Access Compliance Report Public Rights-of-Way (Curb Ramps)

Main Street: ROANOKE_DR		Cross Street: VINEYARD_RD		Location:	NW
ADA ID: RPAT211103112126	Ramp Type:Type 1 - Perpendicular	Initial Pass/Fail: Fail	Overall Compliance: No	Severity Score:	2

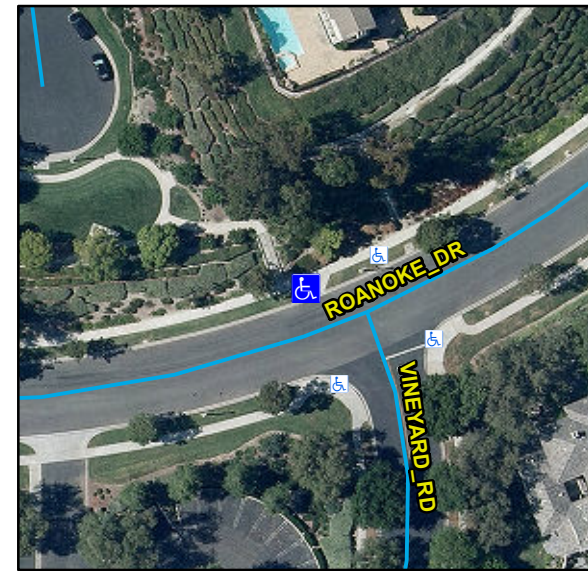
R304.2.2, R204.3, R304.5.3, STD 1115

Remove & Replace Entire Ramp.
